# Technical Service Bulletin

**NUMBER:** 23-044-00

Seat Back Rattle

2001 (PL) Neon

**Fig. 1 SEAT BACK PIVOT BOLT**

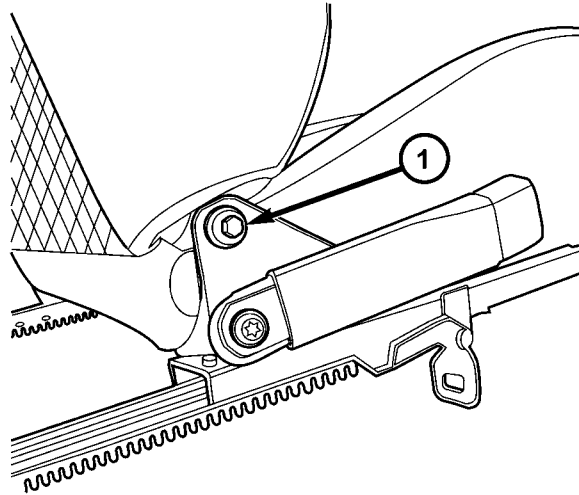
1. Using the procedures provided under the Service Information tab of MDS2, or the information on page 23 – 107 of the 2001 Neon Service Manual (Publication No. 81-270-1025), remove either of the front seats.
2. Remove the seat back pivot bolt (using a 10 mm socket/wrench) (Fig. 1).

**Fig. 2 PIVOT BOLT BUSHING**

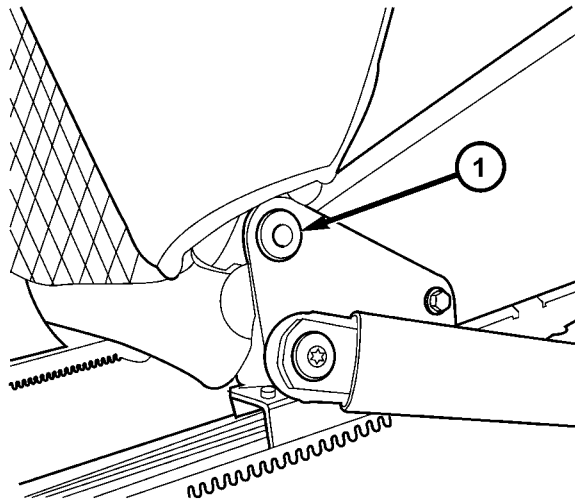
3. Remove the rubber bushing that surrounded the bolt (Fig. 2).

**Fig. 3 BUSHING ORIENTATION**

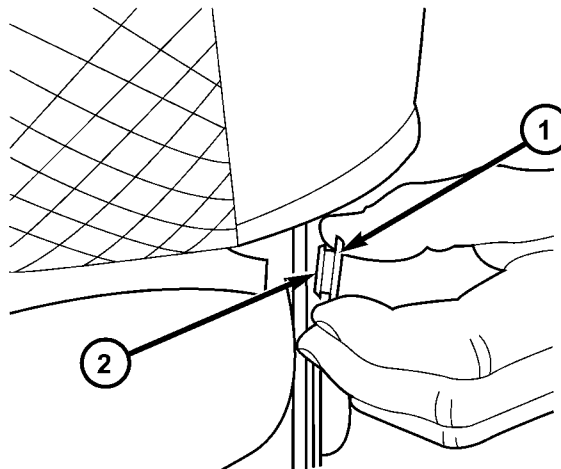
4. Install the new bushing (p/n 04680045). Be sure to orient the bushing with the smaller diameter lip toward the center of the seat, and the larger diameter lip toward the pivot bolt head/washer (Fig. 3).

- 5. Install the new pivot bolt (p/n 05017780AA) and tighten to 28 Nm (21 ft. lbs.) torque.
- 6. Install the seat per the procedures provided under the Service Information tab of MDS2, or the information on page 23 – 107 of the 2001 Neon Service Manual (Publication No. 81–270–1025).
